July 6, 2006 Ref. No. 119503

Morrill's Crossing, Portland, ME - Sound Level Impact Assessment Report Re: Peer Review by Resource Systems Engineering – June 19, 2006

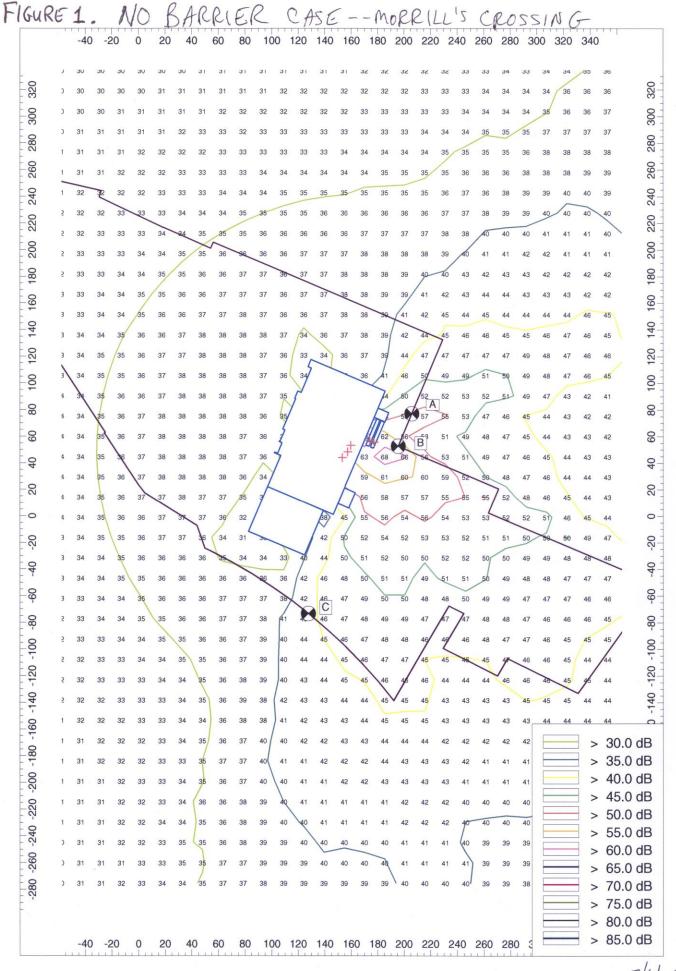
The results of the combined source modeling are shown in the attached Figure 1. The five sources are shown as red "plus" symbols (+). This plot shows the numerical values at each grid point as well as the sound level contours. Figure 1 shows the 60 dBA contour is right at the corner of the site property line. Maximum sound level impacts at the nearest property line from the combined sources are 60.0 dBA at Point "B", 54.6 dBA at Point "A", and 43.2 dBA at Point "C." The attached Table 2 is produced directly from Cadna/A with the results at the three discrete receptors.

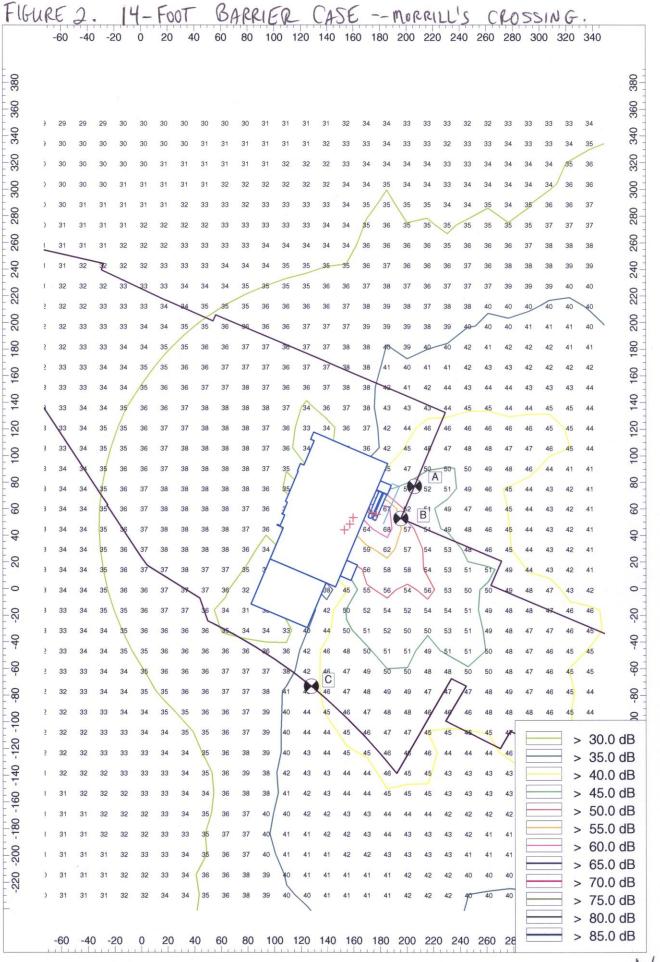
The results of the combined source modeling with a 14-foot high barrier wall are shown in the attached Figure 2. This plot shows the numerical values at each grid point as well as the sound level contours. Maximum sound level impacts at the nearest property line from the combined sources are 53.2 dBA at Point "B", 51.5 dBA at Point "A", and 43.2 dBA at Point "C." The attached Table 3 is produced directly from Cadna/A with the results at the three discrete receptors. The 55 dBA contour remains on the site property. The results of the Cadna/A modeling show that the barrier wall will reduce sound levels approximately 7 dBA over the case without the barrier wall.
